03.1-04

TECHNICAL BULLETIN

Poor Idle Quality –
Normally Aspirated AJ16 Engine –
Valve Timing Modification

MODEL 1995 MY
4.0L NA
VIN See engine no. below

ILLUSTRATION 1

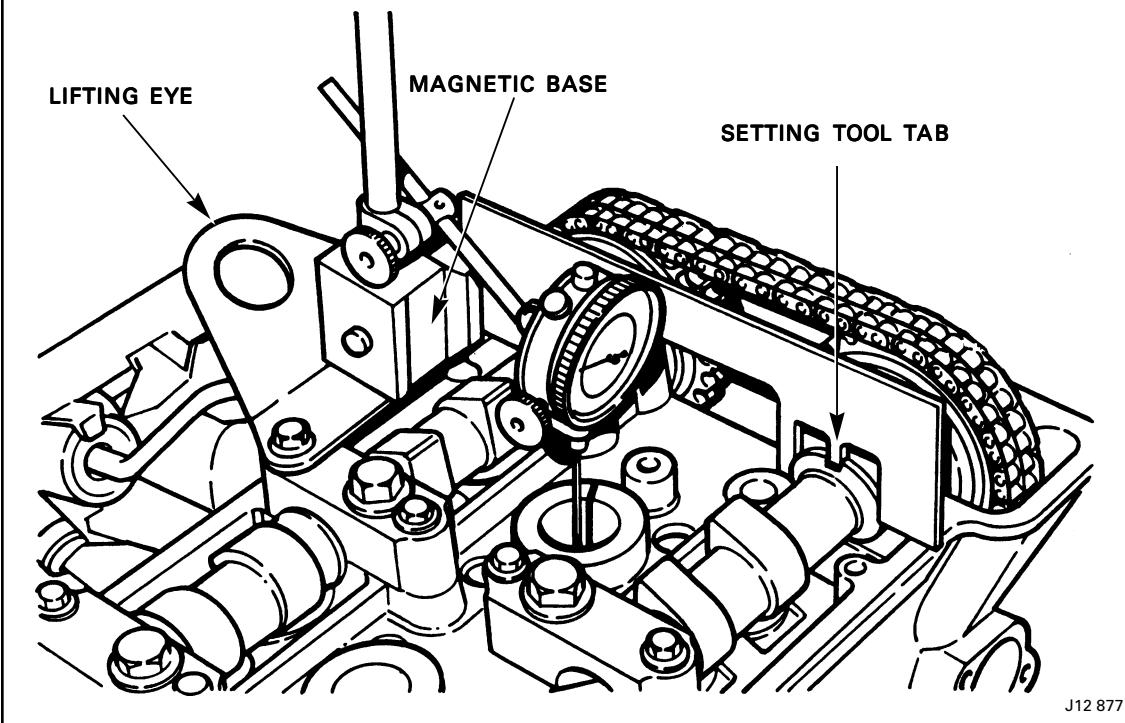
5. Turn the crankshaft until the No. 1 cylinder is at Top Dead Center (TDC) on the compression stroke, i.e. with the cam lobes on the No. 1 cylinder pointing upwards as in Illustration 1. This position can be checked by temporarily inserting the camshaft setting tool 18G-1433/A into the slot on each camshaft.

7. On all engines, attach an engine lifting eye to the intake camshaft cap as shown in Illustration 1.
8. Position the magnetic base of a dial indicator gauge on the lifting eye.
9. Install the dial indicator gauge with an extension pointing downward, into the spark plug bore, contacting the top of the piston.
10. Bend back the locking tabs that lock the bolts holding the camshaft sprocket vernier couplings to the camshafts. Loosen the bolts slightly, but do not remove them.
11. Remove the camshaft setting tool. Rotate the crankshaft back and forth slightly across the TDC position to determine the true TDC point for the no. 1 piston and then zero the gauge.

ILLUSTRATION 2

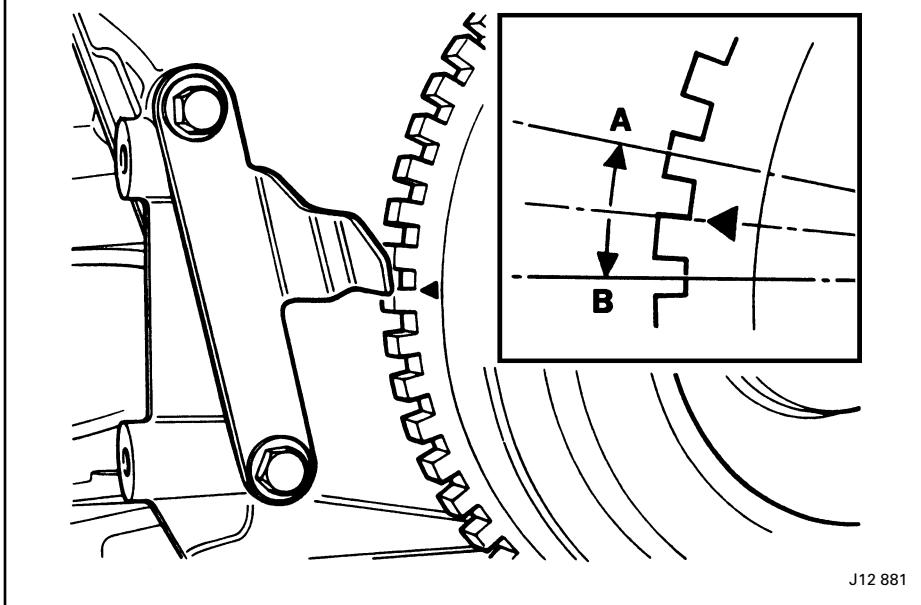
12. Check that the pointer on the front timing cover is in line with the arrowed (TDC) tooth edge on the timing ring, Illustration 2. Realign the pointer if necessary.
13. The crankshaft positions for resetting the camshafts are one and a half teeth on either side of the arrowed (TDC) tooth edge on the timing ring as shown in Illustration 2.
14. Rotate the crankshaft two revolutions in a clockwise direction (viewed from the front of the engine) until the pointer is one and a half teeth before the arrowed (TDC) tooth edge on the timing ring, position A, Illustration 2.

19. Install the locking tabs and the coupling bolts. Lightly tighten the bolts.
20. Remove the setting tool and turn the crankshaft in a clockwise direction (viewed from the front of the engine) until the pointer is one and a half teeth after the arrowed (TDC) tooth edge on the timing ring, position B, Illustration 2.

27. Check both the settings of one and a half teeth before and after the arrowed (TDC) tooth edge on the timing ring, Illustration 2. The tab of the setting gauge should fit in the slot of the camshaft being checked.

ILLUSTRATION 3

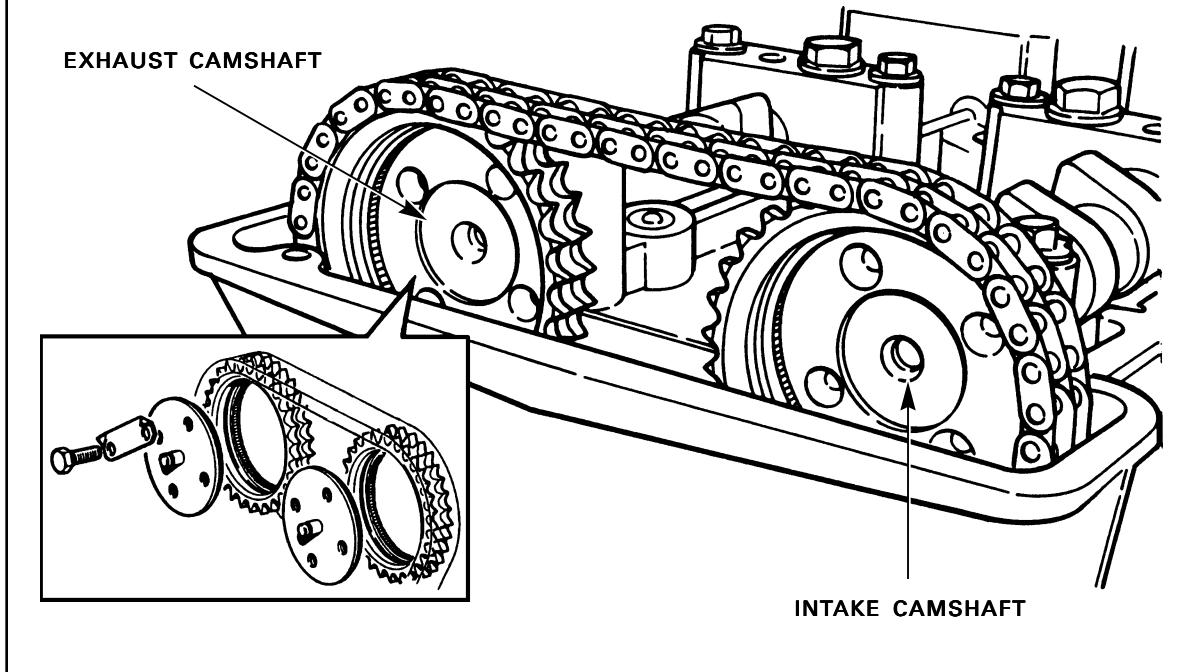
15. Remove the retaining bolts and the camshaft sprocket vernier coupling, Illustration 3, from the exhaust camshaft, but do not detach the sprocket from the camshaft flange. The camshaft is free to rotate inside the sprocket with the coupling removed.
16. Position the camshaft setting tool 18G-1433/A across the camshafts with the positioning tab on the exhaust camshaft, Illustration 1.
17. Turn the exhaust camshaft until the tab on the setting tool engages the slot in the camshaft.
18. With the camshaft in this position, reinstall the sprocket vernier coupling to the exhaust camshaft. This step will require several attempts to find the exact alignment of the vernier splines and the bolt holes.

21. Remove the retaining bolts and the camshaft sprocket vernier coupling, Illustration 3, from the intake camshaft, but do not detach the sprocket from the camshaft flange. The camshaft is free to rotate inside the sprocket with the coupling removed.
22. Position the camshaft setting tool 18G-1433/A across the camshafts with the positioning tab on the intake camshaft.
23. Turn the intake camshaft until the tab on the setting tool engages the slot in the camshaft.
24. With the camshaft in this position, reinstall the sprocket vernier coupling to the intake camshaft. This step will require several attempts to find the exact alignment of the vernier splines and the bolt holes.
25. Install the locking tabs and the coupling bolts. Lightly tighten the bolts.

26. Remove the setting tool and final tighten the camshaft sprocket vernier coupling bolts to 16.2 - 20.6 lb ft (22 - 28 Nm). Bend the lock tabs against the bolt heads.

ILLUSTRATION 4

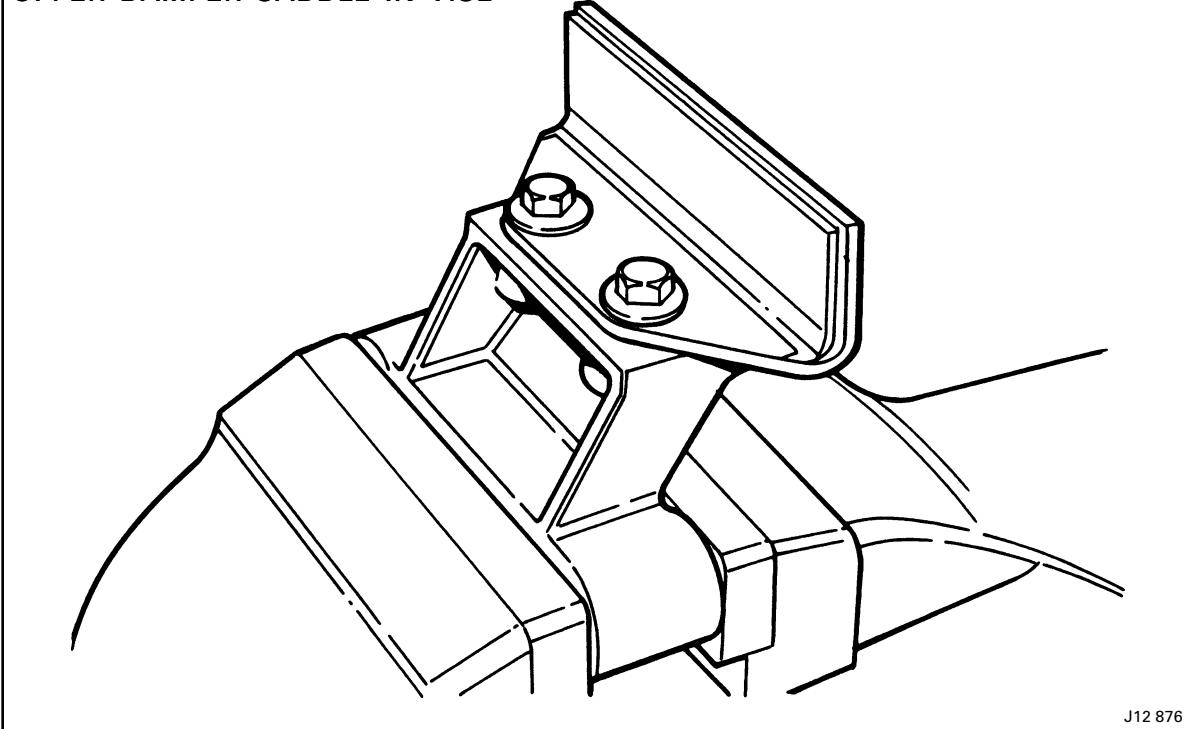
28. Remove the setting tool, the dial indicator gauge, and the lifting eye. Torque camshaft bearing cap bolt to 12.5 - 16.9 lb ft (17 - 23 Nm).
29. On engines with numbers below 9L103934 (XJS Range) or 9J103935 (Sedan Range) only, remove the damper saddle retaining bolts, Illustration 4. Thoroughly degrease the bolts and the saddle. Apply Loctite 545, part number 54531 to the bolt threads and torque to 15.8 - 21 lb ft (21.5 - 28.5 Nm). Install the damper saddle using new cylinder head bolts and torque to 43.5 - 44.9 lb ft (59 - 61 Nm) plus 90 degrees as described in section 2.1 of the AJ16 Engine Service Manual.

NOTE: Engines starting with 9L103934 (XJS Range) or 9J103935 (Sedan Range) do not require modification since the damper saddles are equipped with self locking bolts.

ILLUSTRATION 5

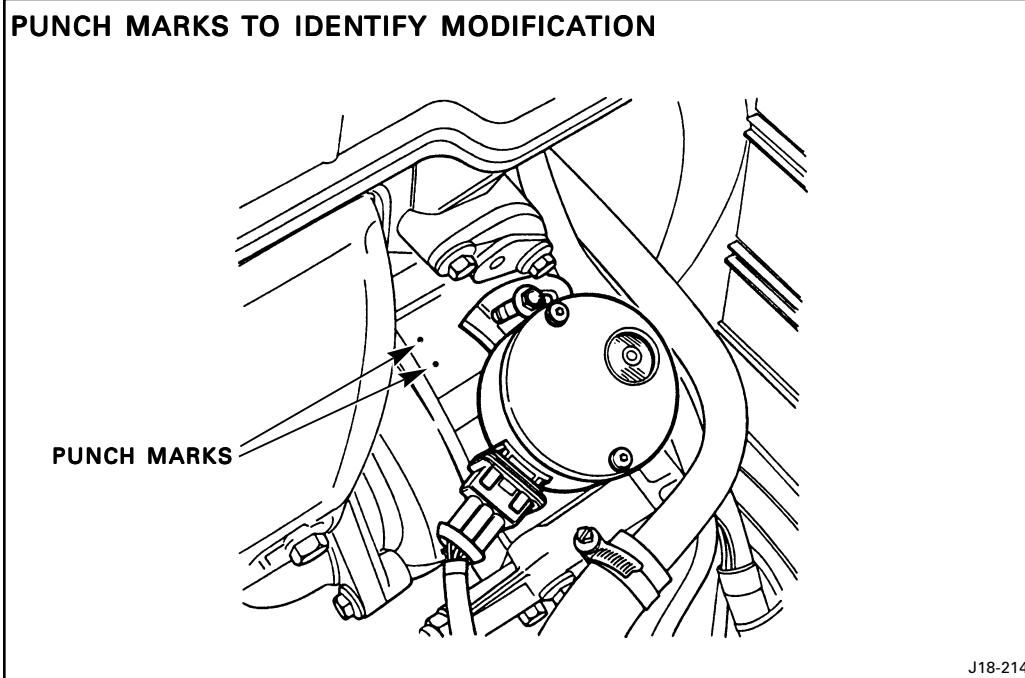
In case of a customer complaint of poor idle quality on a vehicle equipped with the 110 camshafts only, first check for punch marks on the timing cover near the camshaft position sensor, Illustration 5, to determine if the timing modification has already been performed. If not, reset the camshaft timing and spark plug gap as described below.

33. Place two punch marks approximately 1/4 inch apart on the timing cover parallel to the lip, Illustration 5, to indicate that the modification was done.
34. Connect the battery negative cable and reset the clock.
